APPLICATION FOR SUBSURFACE WASTEWATER DISPOSAL PERMIT

Re: Variance to the State of Maine Subsurface Wastewater Disposal
Rules, David Varney's property, North Belfast Ave.

Subject: Variance to the Maine Subsurface Wastewater Disposal Rules, Varney property, Route 3, Augusta

Subsurface Wastewater Disposal Plan

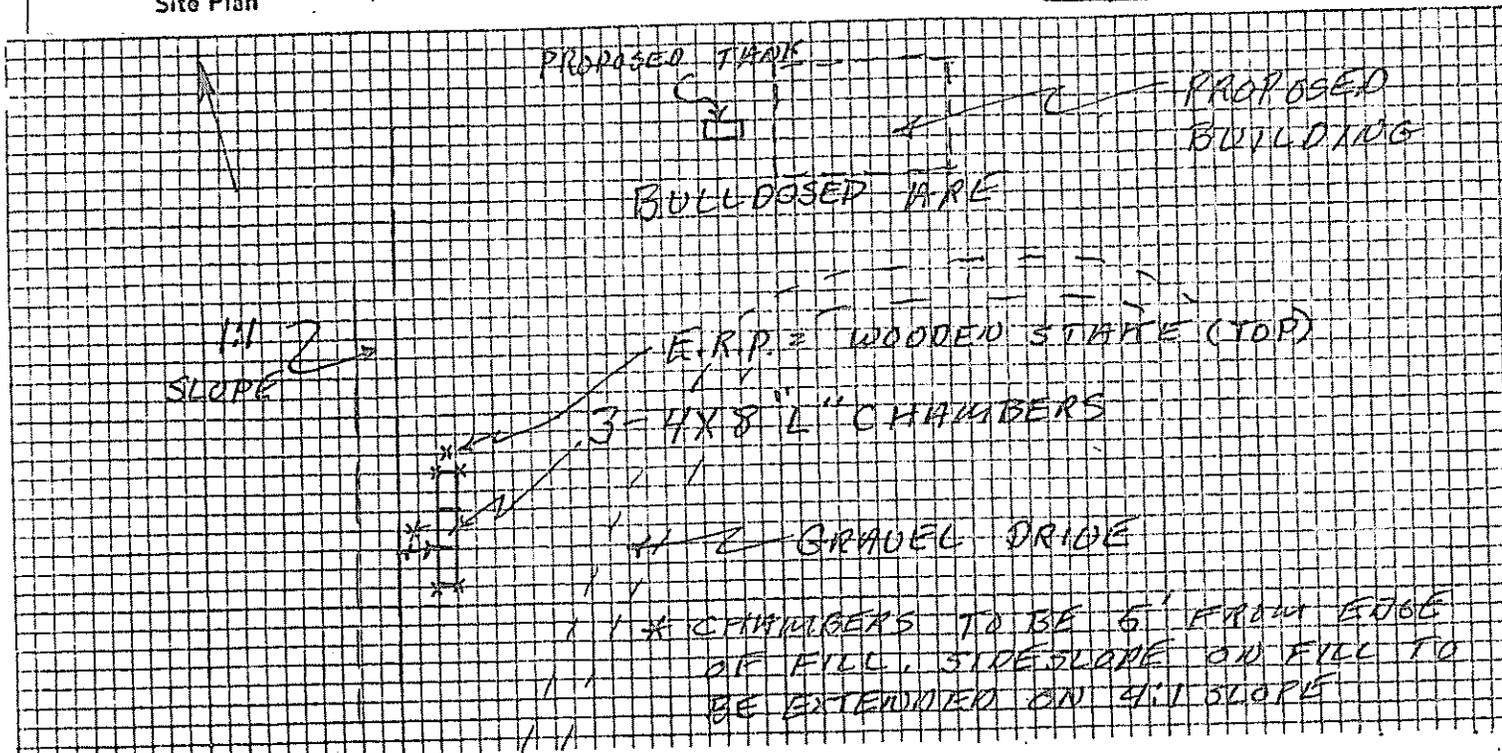
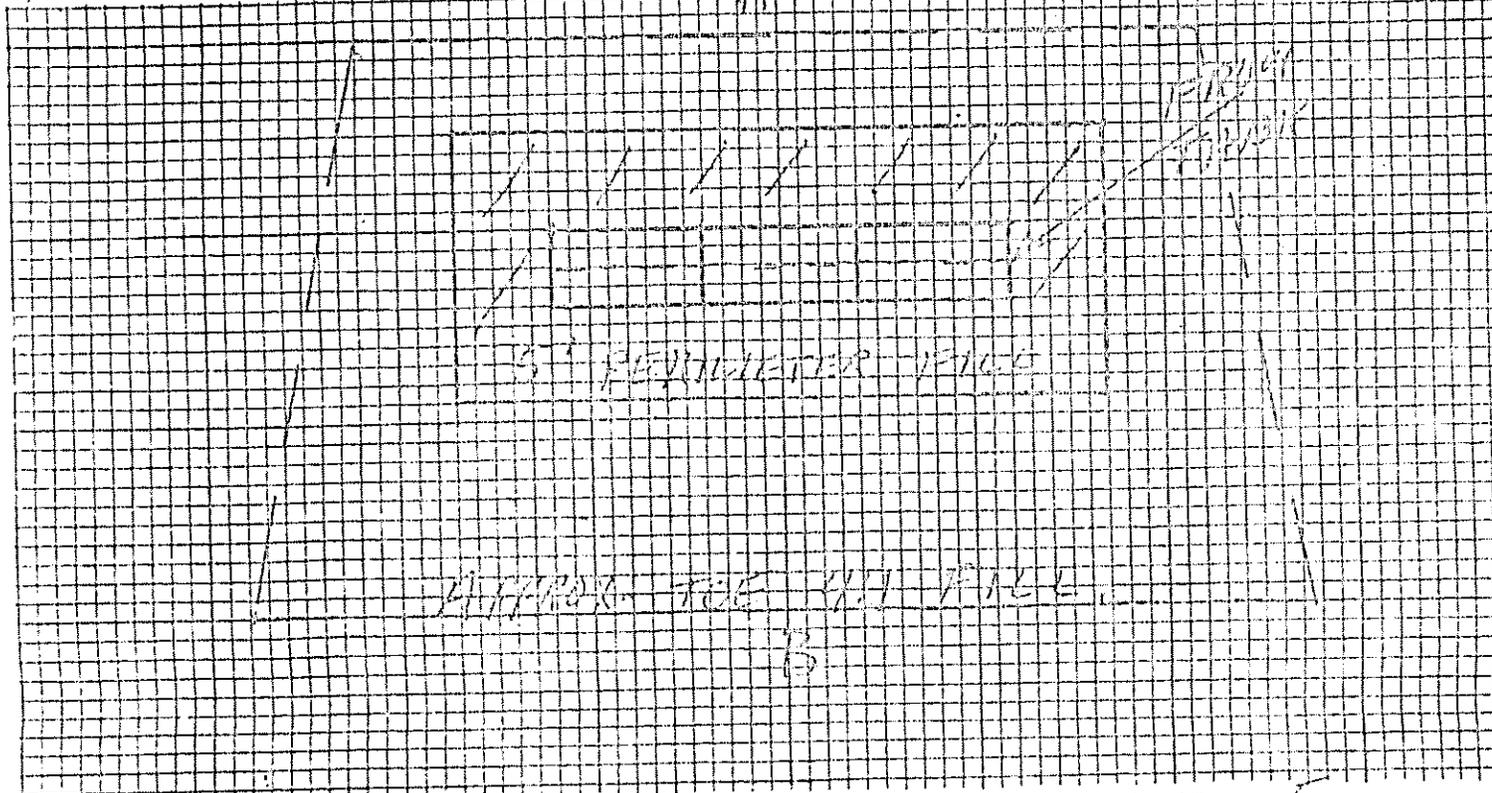
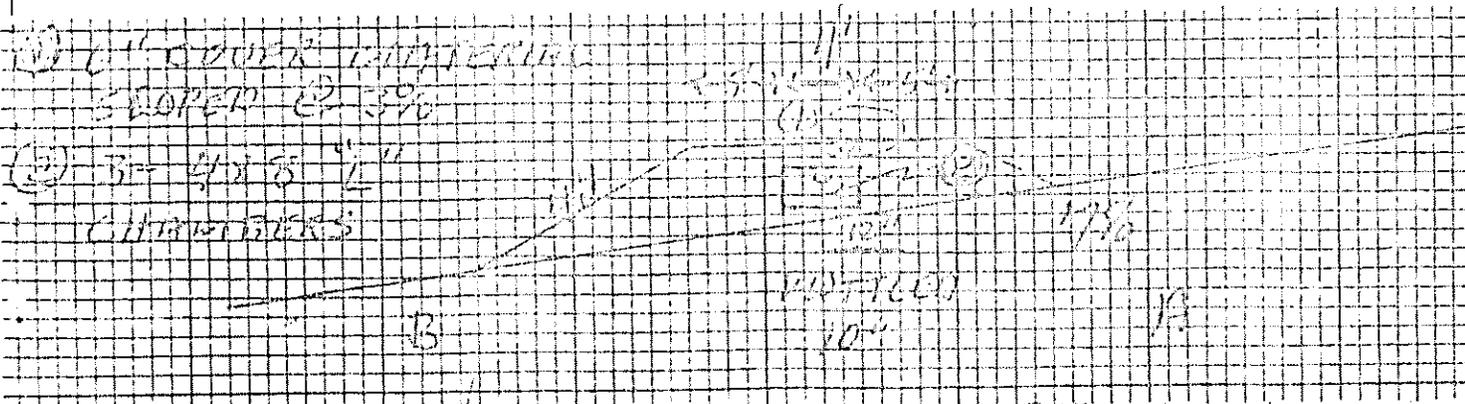
The proposed system is located on a well drained slope. 3 chambers are approximately 5 square feet each. The system is designed to meet the minimum requirements.

A completed MHE-200 Form by William Rideout, SE.; a completed MHE-215 Form signed by David Varney, property owner; William Rideout, SE., and Richard Baker, LPI. The above is accepted as a complete application for variance to the Subsurface Wastewater Disposal Rules. A new subsurface disposal system cannot be installed on the subject property in full compliance with the Rules, because of the installation of a cluster of 3 type 'B' chamber units on category 9D soils with a seasonal high water table at 10 inches and a restrictive layer at 17 inches, the reasons for the variance request.

The installation of a 750 gallon septic tank followed by a cluster of 3 type 'B' chamber units with a total bottom area of at least 96 square feet.

At least 21 inches and 24 inches of fill shall be applied on the uphill and downhill sides of the disposal field, respectively. The fill shall be of a texture similar to the original soil and will provide a 12 inch separation between the bottom of the disposal bed and the seasonal high water table and impervious layer. The fill must be extended in all directions as required by Section 11.D of the Subsurface Wastewater Disposal Rules.

This office points out that the rules require that the Site Evaluator, Mr. Rideout, be retained to stake out the system and elevations at the time of construction of the system.
